Three Mile Island, Unit 1 (TMI Unit 1)  
Facility Operating License No. DPR-50  
NRC Docket No. 50-289

**Subject:** Response To Request For Additional Information – Technical Specification Change Request No. 335: Reactor Coolant System Pressure-Temperature Safety Limit (TAC No. MD4910)

**RESPONSE TO REQUEST FOR ADDITIONAL INFORMATION  
TECHNICAL SPECIFICATION CHANGE REQUEST No. 335  
Reactor Coolant System Pressure-Temperature Safety Limit**

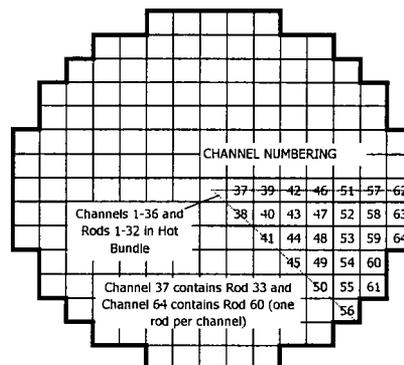
First, it might be beneficial to explain the LYNXT model with a full core of Mark-B-HTP fuel. For TMI Cycle 17, the core is modeled as 177 Mark-B-HTP fuel assemblies (using a 1/8 core symmetry model with LYNXT) as shown in Figure 1. This model is composed of 12 channels. The limiting, or hot, bundle is modeled at the core center.

Channels 1 through 10 represent individual subchannels. Channel 11 represents the remainder of the hot bundle. Channel 12 represents the remainder of the core. The limiting location for the placement of the hot pin is Rod 6 for the BHTP correlation (Reference 2). The limiting fuel rod is modeled as a  $1.800 F_{\Delta H}$  with a 1.65 symmetric axial power shape.

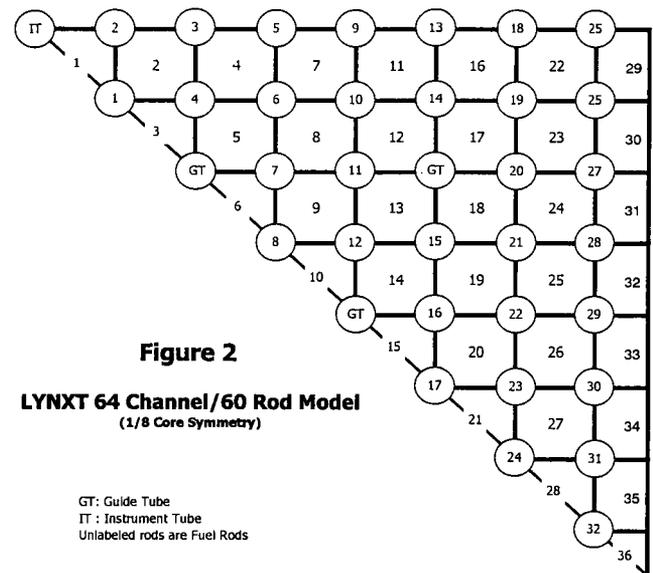
The LYNXT model for the transition core is composed of 64 channels and 60 rods as shown in Figure 2. Again, the limiting fuel rod is modeled as a  $1.800 F_{\Delta H}$  with a 1.65 symmetric axial power shape at Rod 6 when the hot bundle is modeled as a Mark-B-HTP fuel assembly and the DNB performance is predicted using the BHTP correlation. For cases where the hot bundle is modeled as a Mark-B12 fuel assembly, the limiting fuel rod,  $1.800 F_{\Delta H}$  with a 1.65 symmetric axial power shape, is placed at Rod 2 for DNB predictions using the BWC CHF correlation (Reference 3). AREVA has determined the limiting hot rod location for the respective CHF correlations by moving the hot rod throughout the hot bundle to isolate the most severe DNB response. This action assures the most conservative DNB prediction for the design power distribution ( $1.800 F_{\Delta H}$  with a 1.65 symmetric axial power shape at the hot rod) for each fuel design.

The transition core DNB penalty associated with the Mark-B-HTP hot bundle was computed by determining the difference between the DNB performance of the transition core, represented in Figure 3, and the DNB performance obtained using a full core model of Mark-B-HTP fuel assemblies. Both LYNXT models used the 64 channel/60 rod LYNXT model as shown in Figure 2.

**Figure 3**  
**Transition Core Configuration for Mark-B-HTP**  
**Hot Bundle with 85 Mark-B-HTP Fuel Assemblies**  
**in the Core**

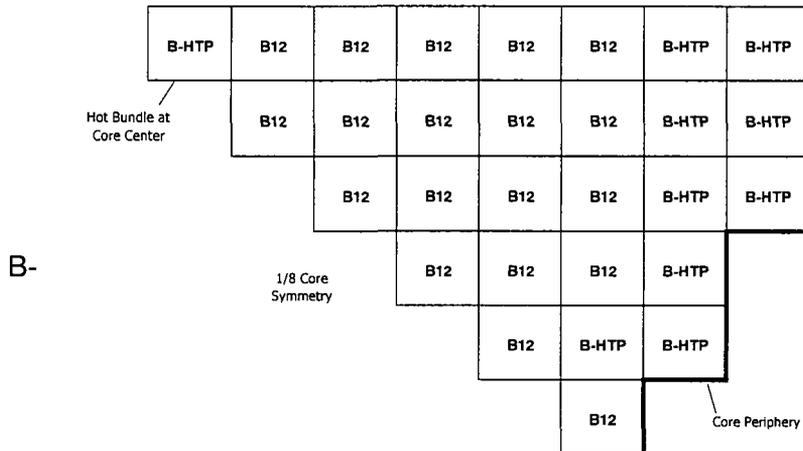
Figure 3 shows the core Configuration1 that accentuates the flow diversion out of the Mark-HTP hot bundle in the transition cycle assuming there are 65 Mark-B-HTP fuel assemblies in the core. (This assessment was actually performed for different numbers of Mark-

B-HTP fuel assemblies in the core. However, the details being described here are for the case with 65 Mark-B-HTP fuel assemblies in the core.) By conservatively placing all the lower pressure drop Mark-B12 fuel around the limiting Mark-B-HTP hot bundle, the most conservative DNB penalty can be determined for a limiting Mark-B-HTP fuel assembly.

As long as the maximum positive DNB penalty is smaller than the DNB margin reserved between the Thermal Design Limit (TDL) and Statistical Design Limit (SDL) shown in Figure 4 for the Mark-B-HTP fuel design, then the Mark-B-HTP full core DNB analysis of record is bounding and applicable for the Cycle 17 transition core. Using the procedure described above, the transition core DNB penalty for the Mark-B-HTP was found to be [ ] DNB points (where 1 DNB point = 0.01) when using the conservative core configuration shown in Figure 3. Sufficient margin has been reserved between the TDL and SDL to offset this transition core penalty.

**Figure 5**  
**Conservative Transition Core Configuration for Mark-B Hot Bundle**  
 (Number of Mark-B-HTP Modeled is less than Actual number in Core)

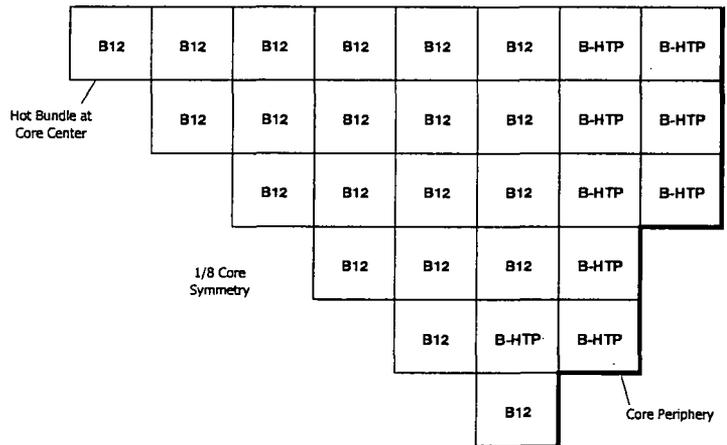
This same procedure is performed for the core Configuration 2 where the hot bundle is the resident fuel design, or Mark-B12. In Figure 5 one can see the placement of the Mark-B12 fuel design into the hot bundle location. In order to maximize the diversion of flow out of the Mark-B12 hot bundle the hot bundle is surrounded with other Mark-B12 fuel assemblies (having a lower pressure drop than the Mark-B-HTP fuel). The placement of Mark-B-HTP fuel adjacent to or near the Mark-B hot bundle would reduce the amount of coolant being diverted from the Mark-B12 hot bundle.

The transition core DNB penalty associated with the Mark-B12 hot bundle was computed by determining the difference between the DNB performance of the transition core, represented in Figure 5, and the DNB performance obtained using a full core model of Mark-B12 fuel assemblies. Both LYNXT models used the 64 channel/60 rod LYNXT model as shown in Figure 2.

If the DNB prediction for a Mark-B12 hot bundle is lower in the transition core than in a full core model for a given statepoint condition, then the DNB penalty is positive indicating the transition situation is not bounded by the DNB analysis based on a full core of Mark-B12 fuel. After determining the DNB difference for the ~100 operating conditions with various axial power distributions, it was concluded that no DNB penalty was necessary for the Mark-B12 resident fuel design. In every case more flow was passing through the Mark-B12 hot bundle as a result of the Mark-B-HTP fuel in the core than would

ATTACHMENT 1

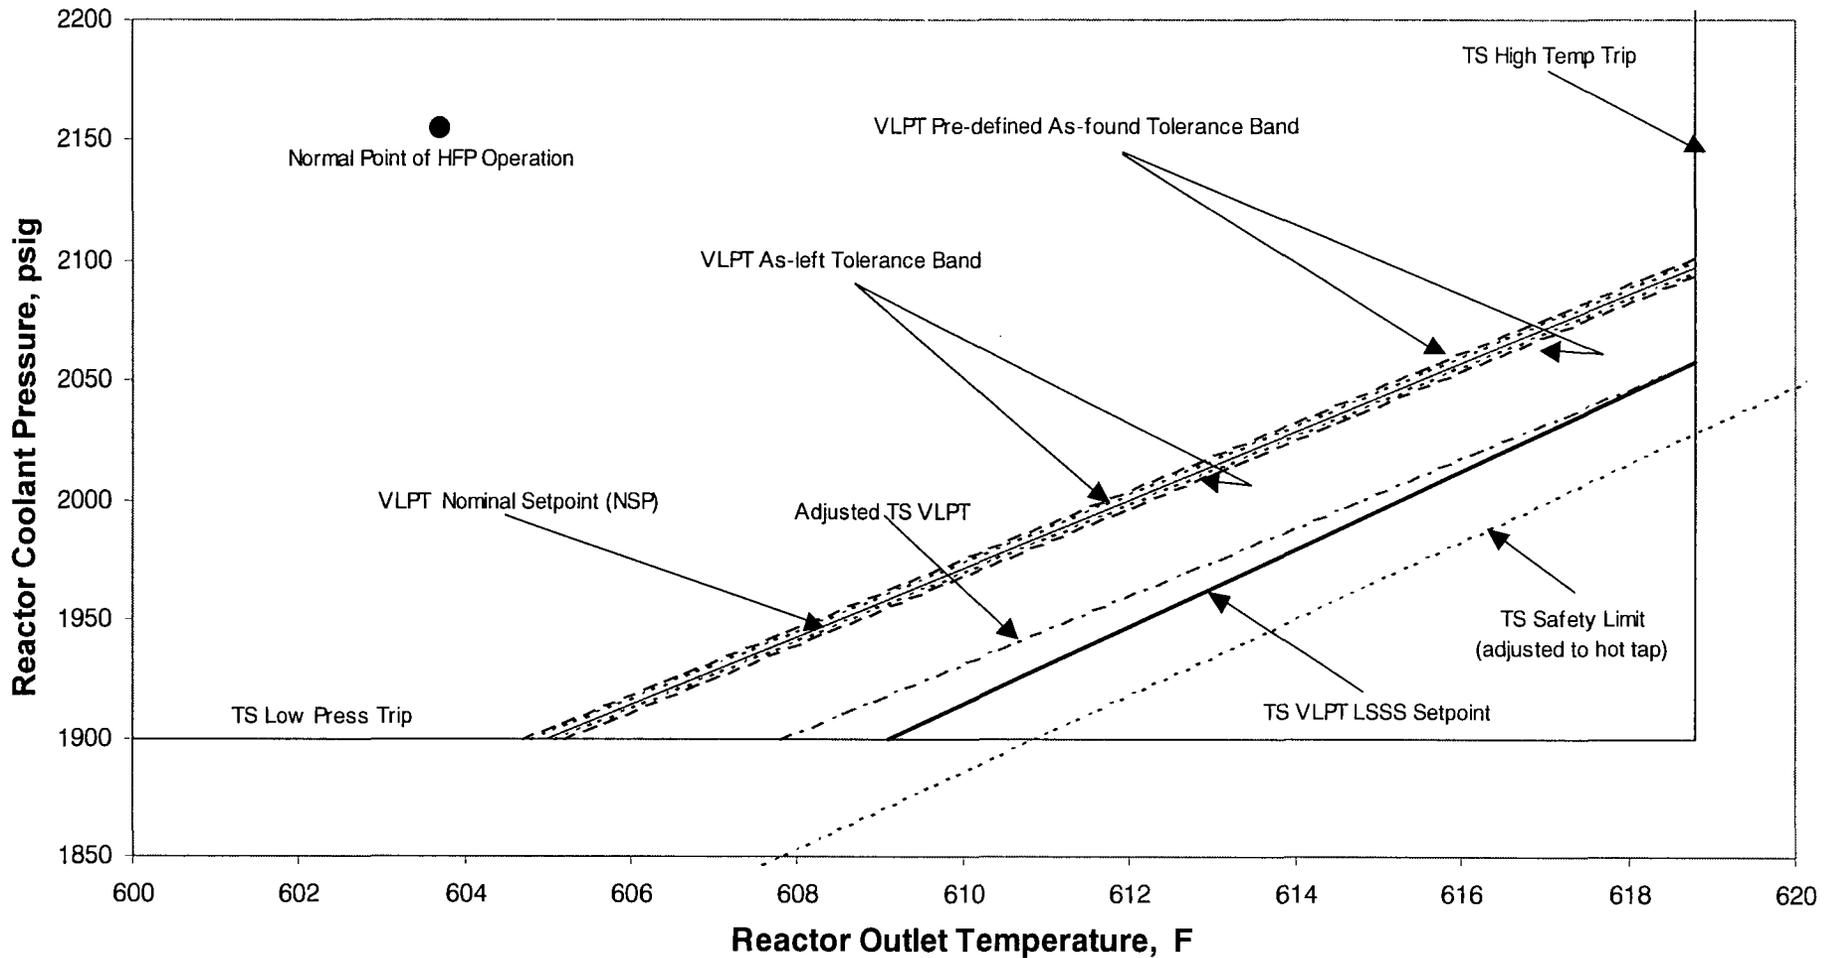
Demonstrate that, for operation with measured values at the limits of the "Acceptable Operation" region of proposed TS Figure 2.3-1, there would be adequate assurance that the actual operating point will be conservative relative to the indicated Safety Limit line, given measurement errors consistent with the instrument channel uncertainties.

Identify the low reactor coolant pressure and high reactor outlet temperature intercept points for:

- (a) TS Variable Low Pressure Trip (VLPT) Limiting Safety System Setting Setpoint
- (b) Adjusted TS VLPT
- (c) VLPT Nominal Setpoint (NSP)
- (d) VLPT As-Left Tolerance Band
- (e) VLPT Pre-Defined As-Found Tolerance Band.

Therefore, the TLU is applied a second time in determining the Total Margin so that the NSP protects the AV in the same manner that the AV protects the Analytical Limit. The surveillance test procedure NSP as-left tolerance is included in the Total Margin because it is not included in the TLU calculation. The additional discretionary margin provides additional conservatism. The NSP does not significantly impact the normal plant operating region. See Attachments 1 and 2 for graphical illustration.

Note 1: The VLPT As-Left tolerance is  $\pm 2.16 \text{ psig}$ . The As-Found tolerance is  $\pm 3.52 \text{ psig}$ . See Attachments 1 and 2 for graphical illustration.
